Staff Report

Re: **HLC Review of Elks Block Redevelopment Proposal**

**ELKS BLOCK REDEVELOPMENT
DEMOLITION OF A CONTRIBUTING BUILDING
MAJOR ALTERATION & SPECIAL EXCEPTIONS
NEW CONSTRUCTION & SPECIAL EXCEPTIONS**

120 E 1st Avenue (Building Proposed for Demolition)
139 E. South Temple (Elks Building);
Approx. 151 E. South Temple (New Residential Building);

Figure 4 - 120 1st Avenue – front facade and existing site plan

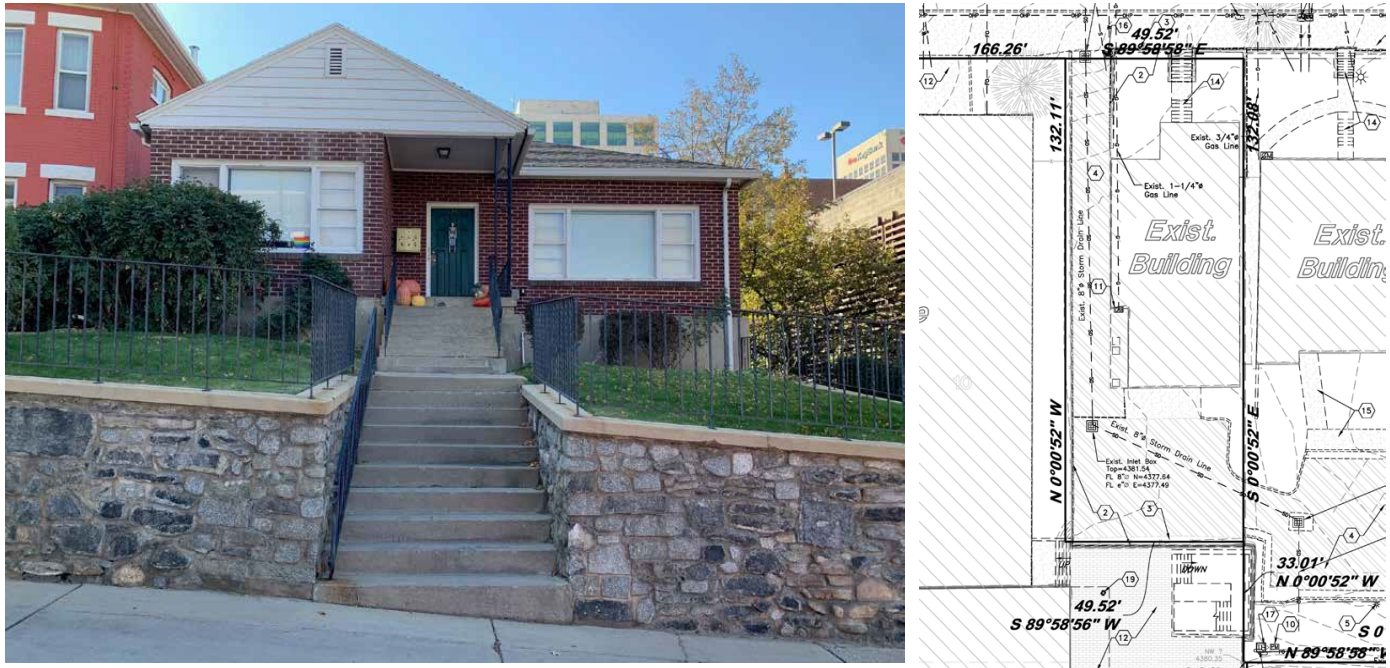
- Informal straw poll by the chair was favorable toward demolition, with some reservations
- Were other options fully considered? Supply more information on structure and history for an informed decision.
- Access from South Temple is less desirable option in terms of design, but 1st Avenue is a residential street and not necessarily great for constant in and out of vehicles.
- Avenues district is diverse architecturally and this house is part of that – fully consider other options.
- Suggestion to salvage materials as much as possible
- “A minor loss for a major gain.”

A key part of the design of this building hinges upon access to the site from 1st Avenue, which as proposed requires demolition of 120 1st Avenue. The applicants have detailed several reasons why this is necessary for the success of this project, including:

- While the 1950 building retains its integrity, it is located at the edge of the Avenues Historic District. There are a non-contributing parking garage and a non-contributing apartment building .
- On the other side are six other historic houses, which would be retained on this streetscape rehabbed as part of this project, maintaining the streetscape and a significant concentration of historic resources for the conceivable future.
- Of the seven historic buildings on 1st Avenue that are within the project site, this one is the most recent and is the only building not considered a contributing structure when the Avenues Local Historic District was created in 1978, and its construction date is the only building that falls outside the district's original 1849-1930s period of significance.

When considered within the overall scope of this project, the applicants' stated importance of the demolition as key to its success, and the potential gains to the city with rehabilitating seven contributing buildings and creating an additional 87 new housing units on the site of an existing surface parking lot, the Commission may find that the proposed demolition substantially complies with the standards.

Figure 8 - Detail of front entrance stairs and tunnel, c.1923

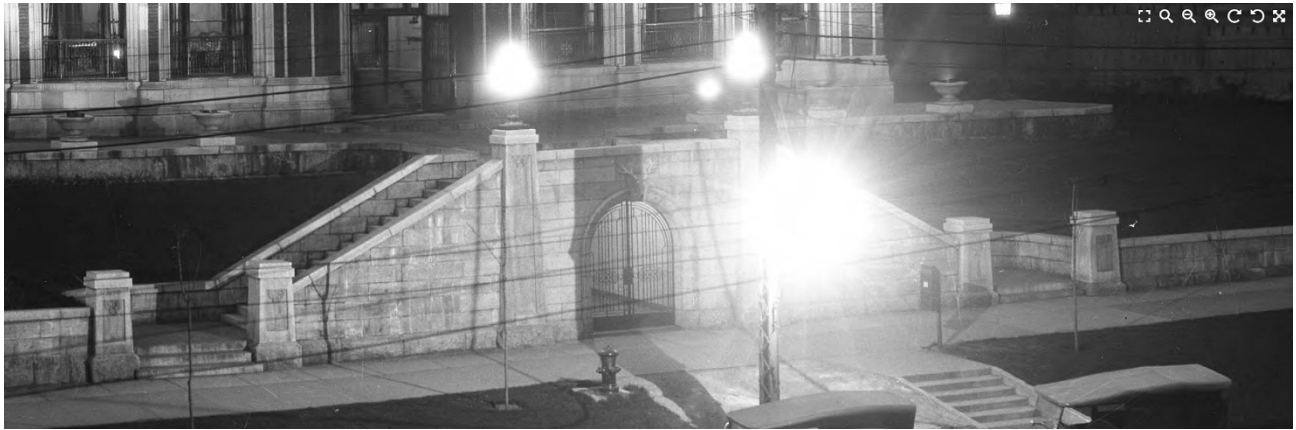
As discussed at length in the HLC's work sessions for this project, the elements composing the front (south) entrance – the existing grade change from the sidewalk to the building entry, the wall at the sidewalk, stairs, podium, tunnel entrance, and decorative features - are original and historic elements of the building's design and construction. The applicant has emphasized that they are also an insurmountable challenge in terms of security, accessibility, and maintenance.

In Staff's opinion, the proposal is not an ideal historic preservation solution, but addresses important design inadequacies and safety issues such as providing one entrance accessible to both abled and disabled individuals. Such trade-offs are inherent in an adaptive reuse project.

The design retains a low retaining wall made from the existing wall materials and the historic light posts, repurposing of other historic materials, a linking structure from the restored entrance arch to the building among several design nods to the former tunnel, and new trees. The plaza would also include moveable tables and chairs. As a condition of approval, Staff recommends that the HLC require the applicant to retain and repair the tunnel entry in place, so that the remaining integrity is not compromised. The balusters at the base of the steps on the front wall also have important decorative elements and should be retained. Placing them in their current locations also preserves the proportions and spacing of the existing front wall.

- 1.** The existing stone tunnel entry, including the tunnel entry, wall, and columns as detailed on the applicant's proposal, will be repaired and retained in place during construction and will not be dismantled and reconstructed, in order to preserve its remaining integrity;
- 2.** The stone balusters and the base of the stairs on either side of the entry will be repaired and placed back in their original locations;
- 3.** Remaining original/historic windows on the south (front) facade will be preserved and repaired;
- 4.** Approval of all final design details, including specific direction expressed by the Commission, shall be delegated to Planning Staff.

Figure 15 - Detail of first floor arched windows on front facade.

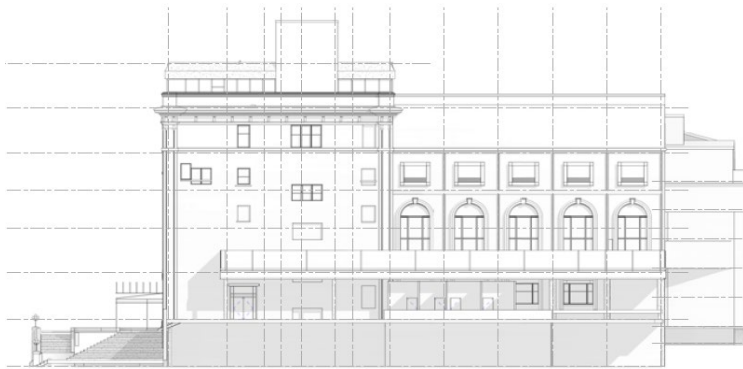
Closer examination of the windows indicates that several original windows remain, including most of the windows on the front facade. The applicants have proposed replacing all existing windows with new metal-clad wood windows with insulated glass. If the HLC finds it appropriate, Staff recommends that the applicant shall retain the remaining original/historic windows on the south (front) facade. They may be retrofitted with double-paned glass and fitted with weatherstripping or other measures employed to seal any leaks. This includes the arched decorative windows on the front facade as well as the metal-framed windows above the arched windows.

The windows that have clearly been replaced on the sides of the building, as well as new windows going into reopened or new windows openings, are proposed to be metal clad wood, as well. Staff's opinion is that there is more flexibility in the materials and design used on these windows. A simple profile that does not duplicate the exact original profiles could be appropriate at these locations.

After the work session discussions and working with staff, the applicants have supplied additional information and details on the windows proposed for restoration and replacement, as well as details on the proposed windows for new or restored openings. That information is found in Attachment B3; Staff's Analysis is found in Attachment J. With the exception of windows on the front facade as discussed above, Staff finds that the proposed new windows are generally compatible with the existing historic windows and recommends that the HLC approve these changes and delegate approval of a final window selection to Staff.
